Technical Service Bulletin

| Subject: CREAKING NOISE FROM FRONT LOWER ARM BUSHING / CLUNKING NOISE FROM FRONT SHOCK ABSORBER COIL SPRING WHEN DRIVING OVER BUMPS | Bulletin No.: 02-001/20 |
| | Last Issued: 01/09/2020 |

2016-2020 CX-9

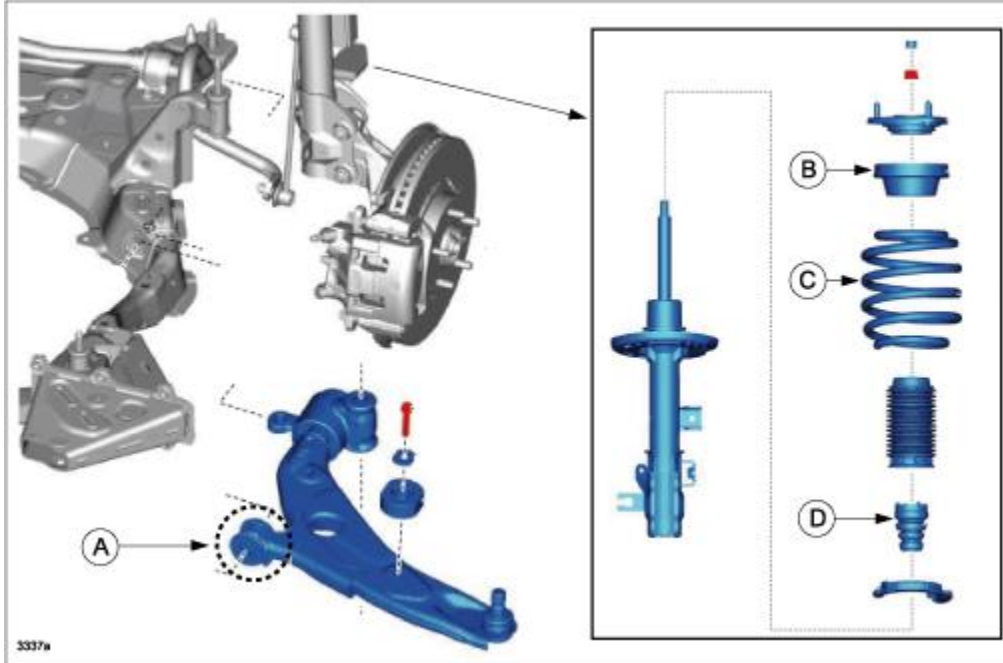
Some vehicles may exhibit one or more of the following noises from the front suspension:

1. A creaking noise from under the front of the vehicle (front lower arm bushing) when driving over bumps at approximate 12 - 25 mph (20 - 40 Km/h). The noise occurs when the road surface is wet or after the vehicle has been washed. The noise becomes more noticeable as the bumps get higher. The creaking noise is caused by the front lower arm bushing (A) making a stick-slip noise during wet road conditions.
2. A clunking noise from the front coil spring when driving over bumps. The clunking noise is due to stick-slip between the front strut bearing (B) and the coil spring (C).
3. A popping noise from the bump stopper (D) when driving through gutters.

To eliminate the noise, the following mass-production changes have been made:

1. The coating treatment of the lower arm bushing has been changed to reduce friction and prevent stick-slip.
2. Protectors have been installed onto the coil springs to prevent stick-slip.
3. **The bump stopper has been modified and grease application has been added to prevent the stick-slip.**

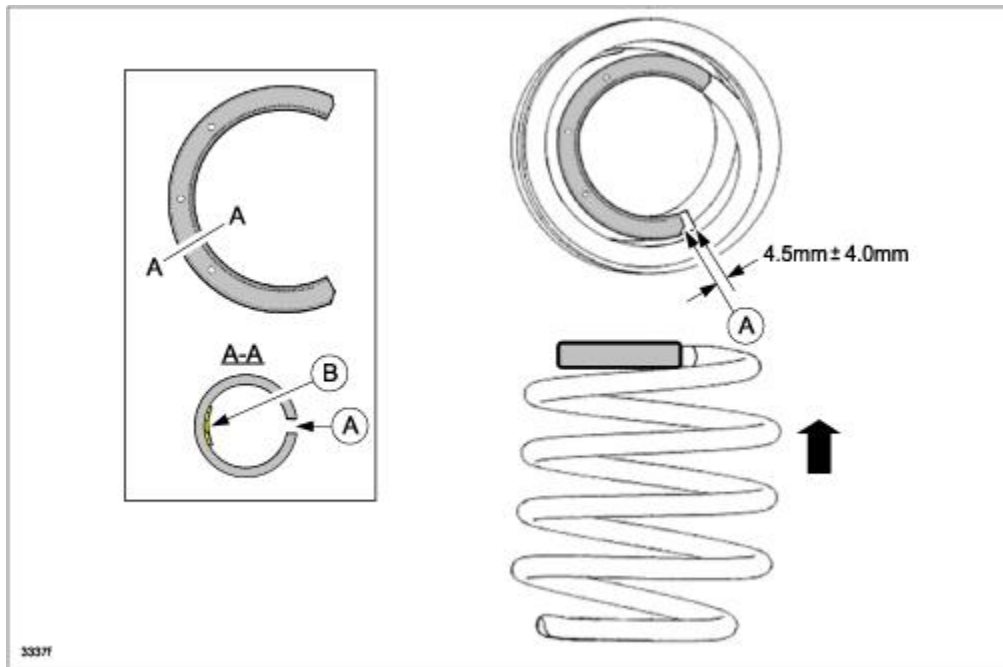
2. Degrease one turn of the spring from the top.
3. Install the protector onto the coil spring aligning the end of the protector as shown below.

NOTE: Install the protector so that the gap (A) is: **4.5 +/- 4.0mm (0.177 +/- 0.157 in)**

4. The inner side of the protector contains adhesive glue (B), so, after the installation, press on the protector to adhere it to the spring.
5. Using the modified bump stopper, assemble and install the shock absorbers according to the instructions on MGSS online (FRONT SHOCK ABSORBER AND COIL SPRING REMOVAL/INSTALLATION).
6. Verify the repair.

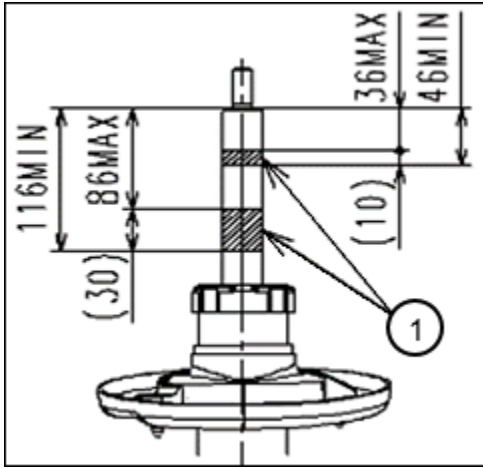
Repair 3 (For Vehicle Type A, B andC): Replace the bump stopper with modified service part (**affected side(s)**)

1. Replace the bump stopper with the modified service part (**affected side(s)**) according to the instructions on MGSS online (**FRONT SHOCK ABSORBER AND COIL SPRING REMOVAL/INSTALLATION**).

NOTE: Before installing the new bump stopper, apply rubber grease to the area (1) on the shaft as shown below. The grease may be applied outside of the area.
